GOVERNMENT OF THE DISTRICT OF COLUMBIA
DEPARTMENT OF TRANSPORTATION

MEMORANDUM

SUBJECT: BZA Case No. 19722 – 925 5th Street NW

Figure 1 – Loading Movements and Alley Access (Source: Dewberry, Exhibit 9A1, provided by the Applicant on 1.29.18)

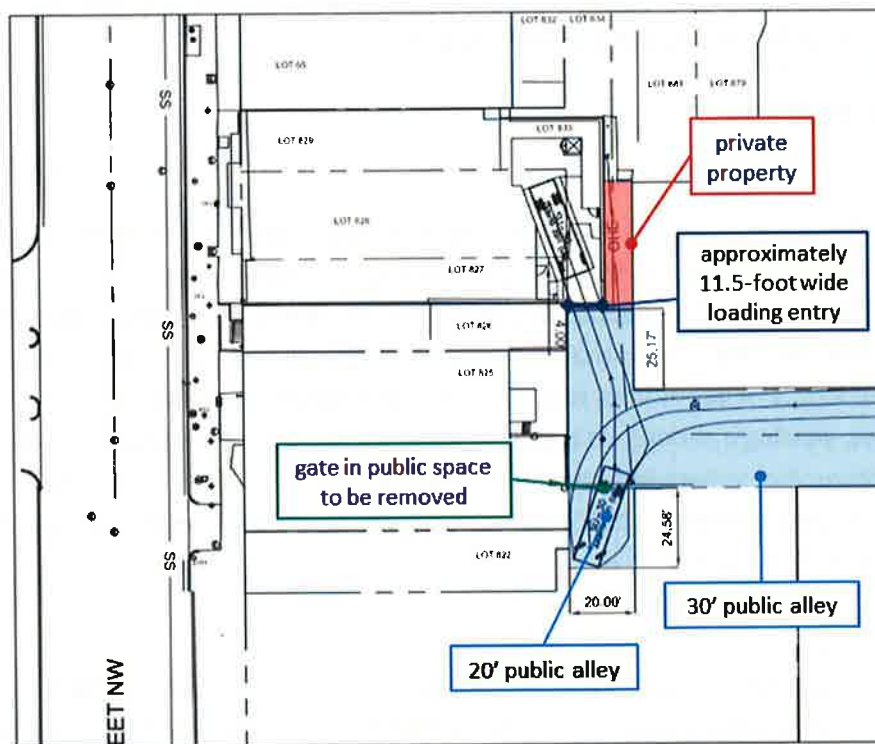
- An existing gate within public space in the southern portion of the public alley's hammerhead will need to be removed for trucks to be able to make the necessary turning movement. The Applicant will need to report the violation to DDOT's Public Space Regulation Division;

Figure 1 demonstrates that the site's alley access is constrained by existing walls on adjacent properties, limiting the entry aisle of the alley to be 11.5-foot wide. As such, the Applicant may need to request additional zoning relief from subtitle C § 904.5. DDOT defers to the Zoning Administrator for an official determination on the need for additional relief. DDOT notes that trucks will need to back into the proposed angled space, which will require the removal of an existing fence at the alley's hammerhead, as shown below. The backing movement may require the assistance of a freight laborer or loading manager. While the movement is not ideal, the Applicant has proposed to mitigate the site's constraints through the provision of a loading management plan. The plan will dictate how vehicles should enter and exit safely, list a designated loading manager, and address how circulation conflicts will be avoided in the alley.
